Penn-Branch Citizens/Civic Association

Re: *BZA Case 16753: Application of Penn Branch LLC and SBA, Inc.— Proposed Monopole at Penn-Branch Shopping Center*

BZA
Case No. 16753
Exhibit No. 89

1 / C2 GRADING, EROSION & SEDIMENT CONTROL AND LANDSCAPE PLANS

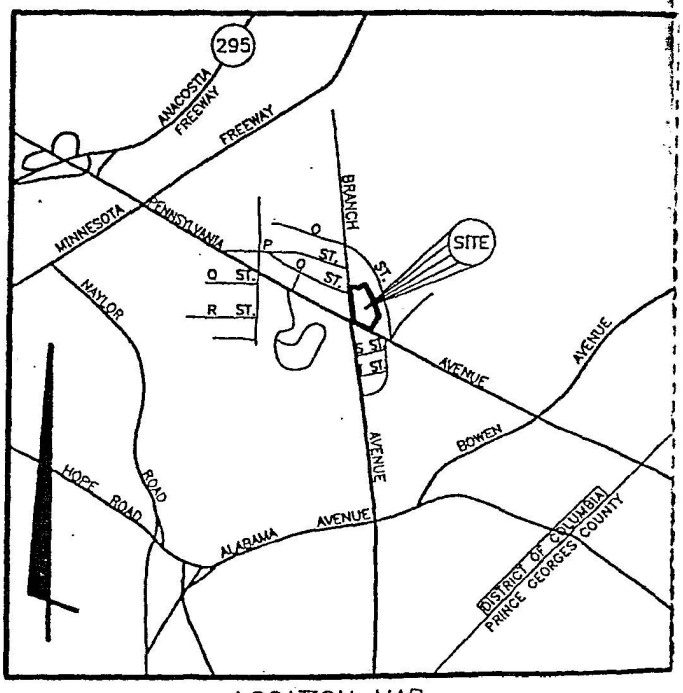
Incomplete request for zoning relief. Some of the drawings submitted by the applicant show a footprint labeled "proposed compactor slab on concrete caissons." The "Description of Work" on the first page of Applicant's drawing state in relevant part, "construct area to place 34x8 trash compactor." There is a separate area marked "Dumpster Area." *See* Attachment C. The application states, "the Applicant proposes improvements to the Penn-Branch Plaza parking lot, including relocating the garbage

The Association assumes that the Applicant intends to build a compactor and a dumpster enclosure as elements of its total project, of which the monopole is the principal aspect. If so, that compactor appears to require additional zoning relief beyond that requested for the monopole.

The shopping center is a C-1 use located on a lot split-zoned between C-1 and an R-1-B. The parking lot carries the residential designation. At present, trash generated by the shopping center is collected in dumpsters and hauled away. Such passive trash disposal is a necessary and normal incident of maintaining a neighborhood shopping center, -and an unavoidable non-conforming activity on this R-1-B site. The addition of a mechanical compactor, with its attendant noise, is a sufficiently different activity as to constitute an extension of a non-conforming use. At a minimum, a compactor would appear to require relief under 3108.2.

The application does not describe in detail the size, height, bulk, manner of operation or extent of use of the proposed compactor. During what hours will it be actively compacting, and how long will any machinery run at a time? It cannot be determined whether the compactor is intended to serve only Penn Branch tenants or whether the Applicant intends to offer compacting services to other users. The Applicant's drawings indicate that dumpsters will continue to be present on the site even though the compactor presumably would reduce the need for dumpsters.

C. Detail from Applicant's Drawings showing "Dumpster Area" and "Compactor Slab"
